FARRAGUT MUNICIPAL PLANNING COMMISSION

AGENDA

February 16, 2023

REPORT TO THE FARRAGUT MUNICIPAL PLANNING COMMISSION

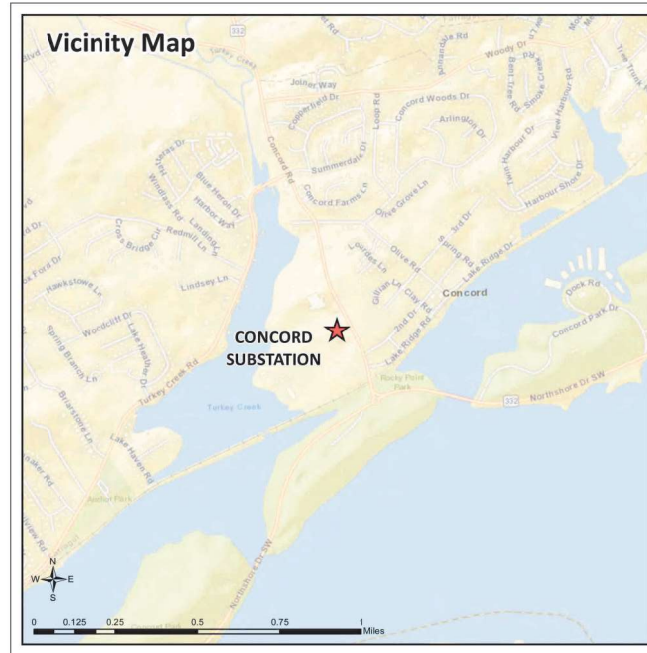
DISCUSSION: The access easement is not owned by FUD and LCUB has encountered issues with the property owner over the access. Consequently, LCUB has been forced to explore an alternate access which would involve Concord Road. This has resulted in a need to revise their site and landscape plans. The proposed access is now off Concord Road roughly 35 feet from the south property line of the FUD tract. Concord Road is a major arterial and accesses are to be a minimum of 400 feet apart. The proposed access is over 400 feet from the access easement that LCUB was originally going to use but roughly 275 feet from the driveway to the south that services an existing single-family home. As a result, the requested access onto Concord Road will require a variance from the distance between driveways requirement in the Driveway and Other Access Ways Ordinance.

The proposed access has been reviewed by the Town Engineer and he is recommending approval of the variance given that there is a raised median through this portion of Concord Road which effectively makes this access a right in right out. This access will also have very limited use and service a substation which will not likely change use to something that would generate more traffic. The access will have to be coordinated with the Town to minimize disruption to the walking trail that the access would have to cross. The access will also have to be approved by TDOT. Resulting from the change in access LCUB will be submitting a revised landscape plan that will be taken to the Visual Resources Review Board likely this month.

This need for a revised access has added cost to the project and, as part of this site plan, LCUB is requesting that the west side of the substation compound be permitted a black chain link fence. This would be the elevation that faces the wastewater treatment facility. The remaining three sides of the compound would include a brick wall like the LCUB substation off Westland Drive (9461 Westland Drive) across from Mourfield Road. Staff supports this revised fence/wall request.

RECOMMENDATION: Included in the packet is the revised site plan. Staff is recommending approval and will note any conditions as part of the staff recommendations that will be provided prior to the meeting.

CONCEPT PLAN OF:
VIRTUE VIEW FARM

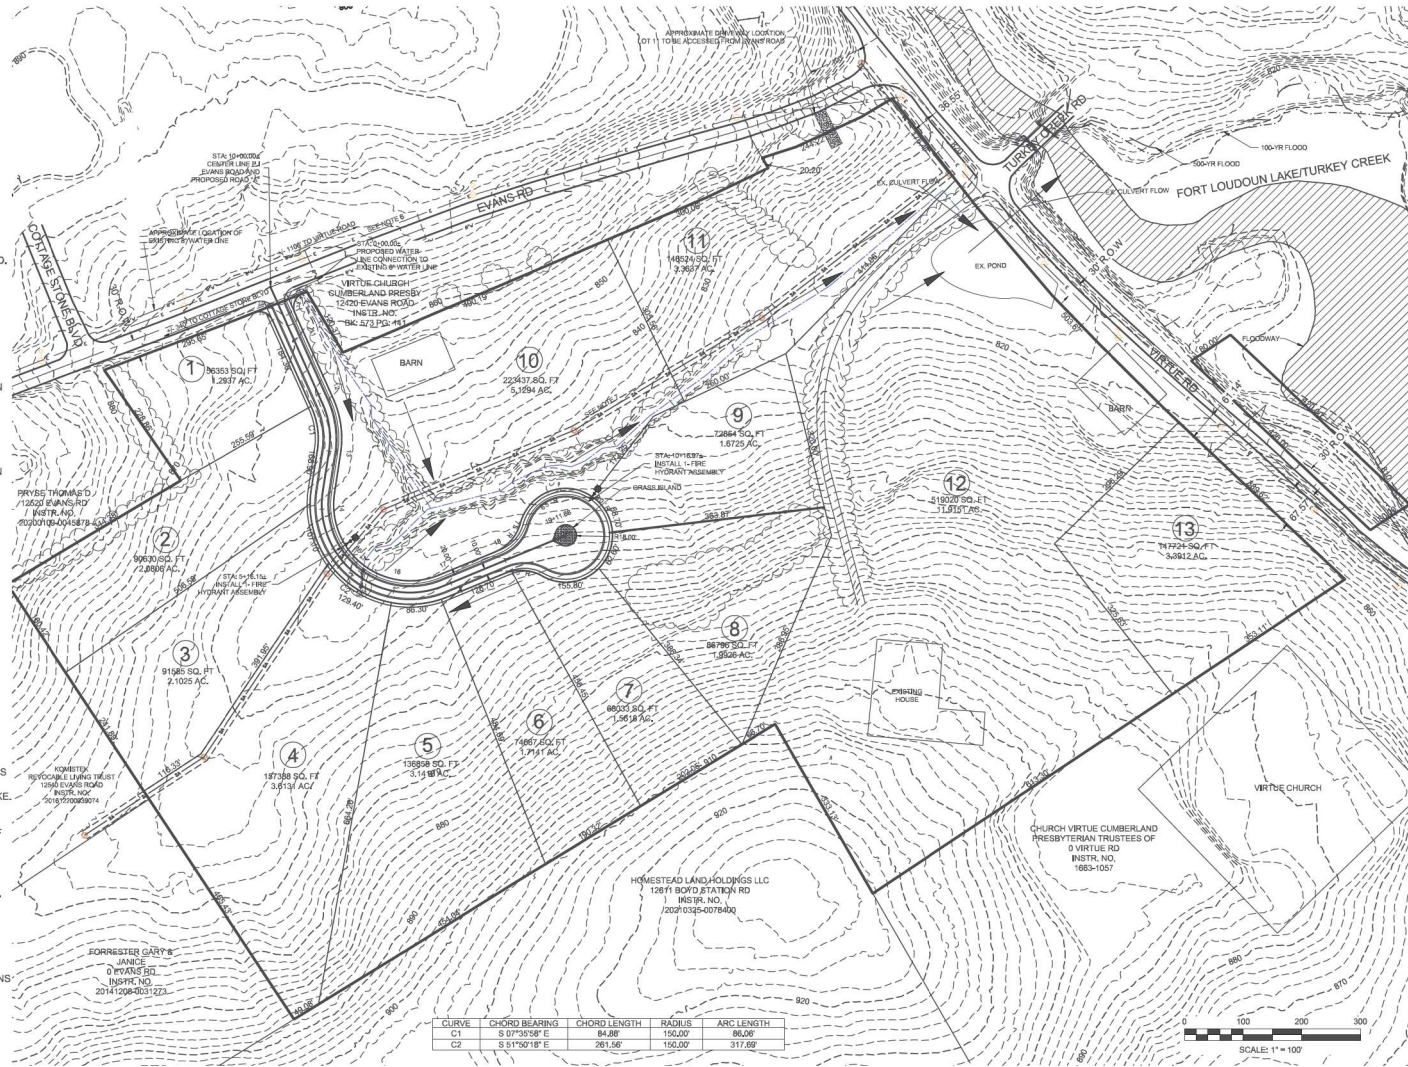
DISCUSSION: Based on the feedback received, the Planning Commission expressed support for the following variances that will need to be formally acted on as part of this agenda item (all other requirements of the Subdivision Regulations must be met and a note to this effect will need to be added to this plan):

1. No detention basin given the proximity of the property to the lake, scale of the proposed subdivision, and size of the proposed lots.
2. Street pavement width reduction from 26 feet to 20 feet with shoulders and grassed swales rather than curbing and storm sewers given the size of the lots, number of lots, topography, and enhanced water quality benefits. The request for the street to be private and gated was not supported so the concept plan is now showing a public street that will not be gated.

6. No road or pedestrian improvements along Virtue Road or Evans Road given the number of lots proposed and limited vehicular and pedestrian traffic generated by the development. The original request to have no pedestrian facilities for the development was not supported so the concept plan is now showing a 5-foot sidewalk along one side of the public street that will be constructed for this subdivision. This sidewalk will terminate at Evans Road.

RECOMMENDATION: The revised concept plan is included in the packet. Staff would note that this is only a concept plan and there could be some minor adjustments when the more detailed preliminary plat is submitted for the utilities and construction of public improvements. Some clarifications are also needed on the concept plan regarding existing property lines and roadway centerlines. These will be included as comments in the staffs' review of the revised concept plan. Staff will make a recommendation at the meeting.

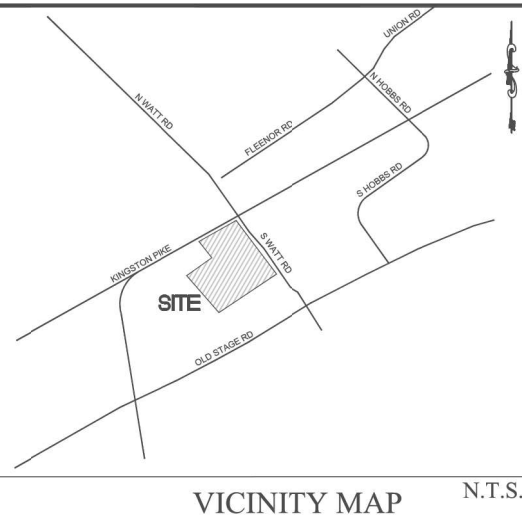
DISCUSSION: The supplemental items are shown and explained on the revised site plan set included in the packet. Based on updated survey information, the amendments include the following:

1. Grading adjustments to account for errors in the original grading plan.
2. Narrowing a driveway section to 22 rather than 24 feet at the south side of the pool and clubhouse.
3. Adding a guardrail along the top of retaining walls near the pool and clubhouse.
4. Relocating the arbor at the pool area from the north to the west side of the pool.
5. Adding a retaining wall at the west side of the relocated arbor.
6. Adjusting the extent of the dog park and adding concrete pads for benches.
7. Modifying the location of the trash compactor.

RECOMMENDATION: The revised site plan supplemental set is included in the packet. Staff is reviewing this and will make a recommendation at the meeting.

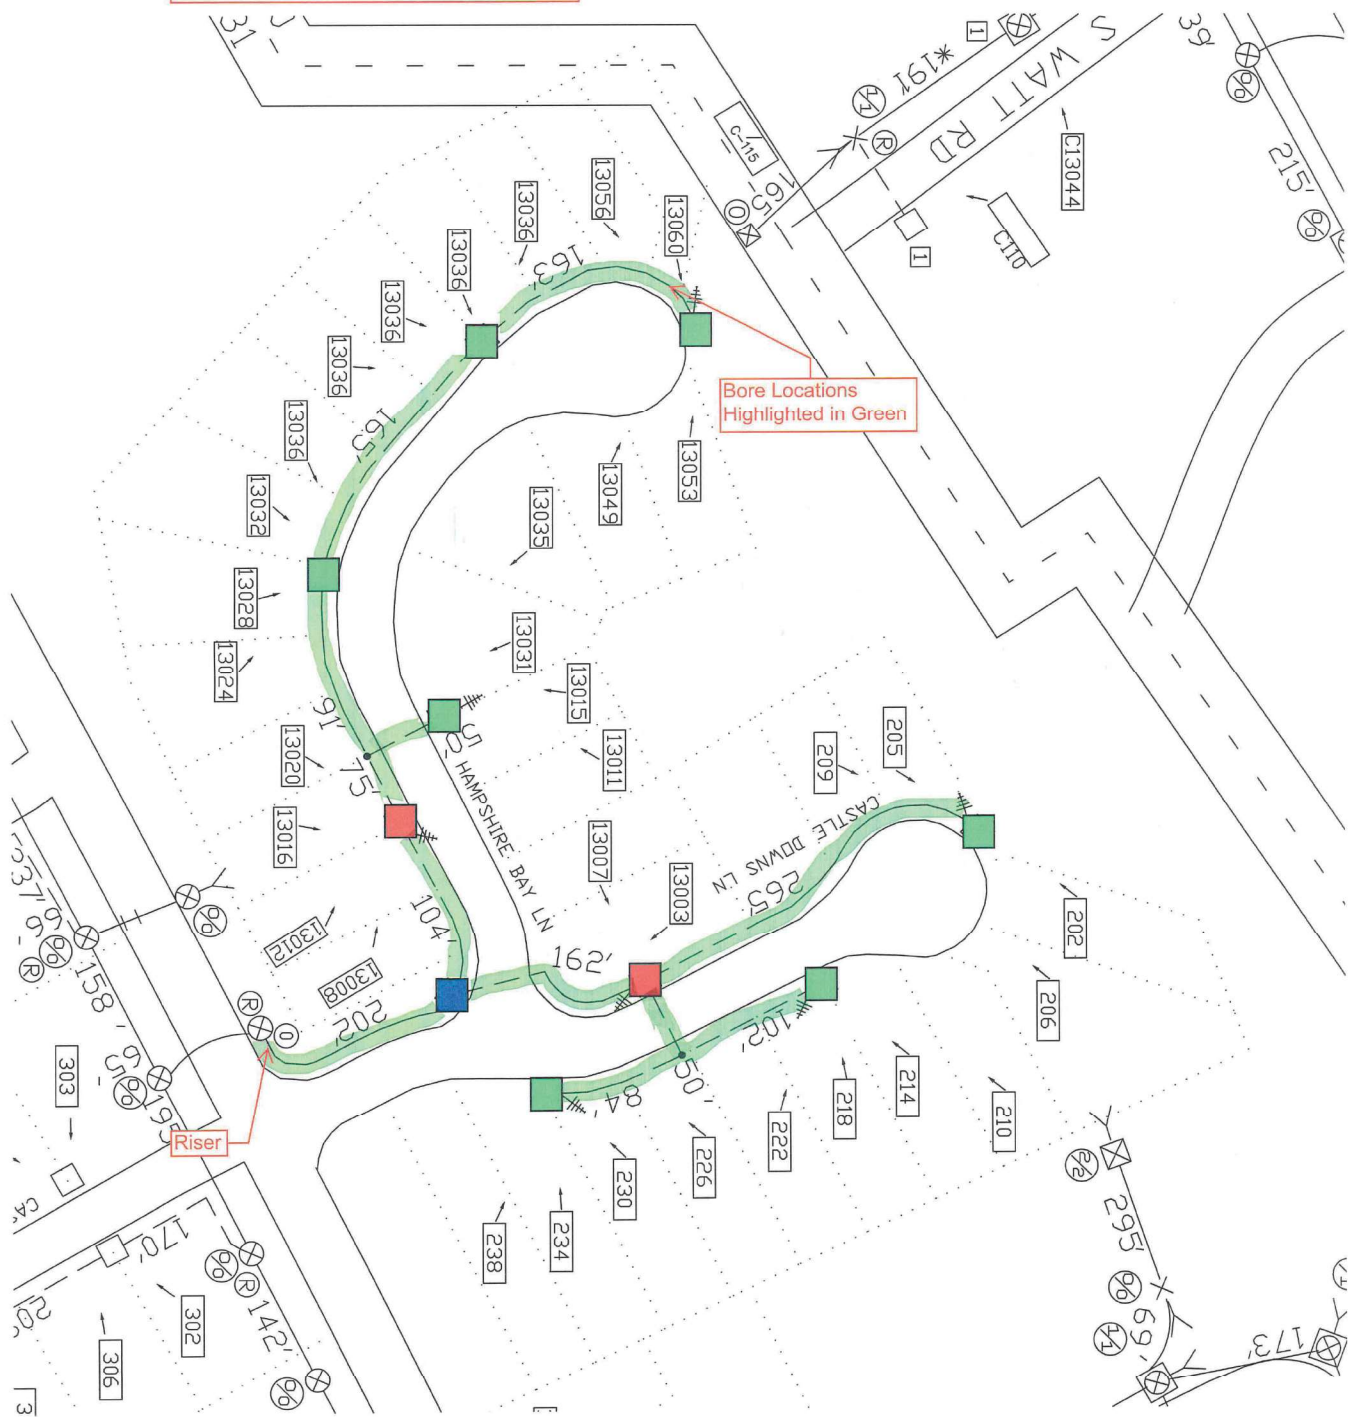
RECOMMENDATION: The information submitted as part of the right of way permit is included in the packet. In addition to obtaining the right of way permit and coordinating work with the Town's engineering department, a letter of credit will be required to ensure affected areas are restored to their pre-disturbance condition. As noted above, all remaining work is to be conducted with directional boring rather than open trench installation.
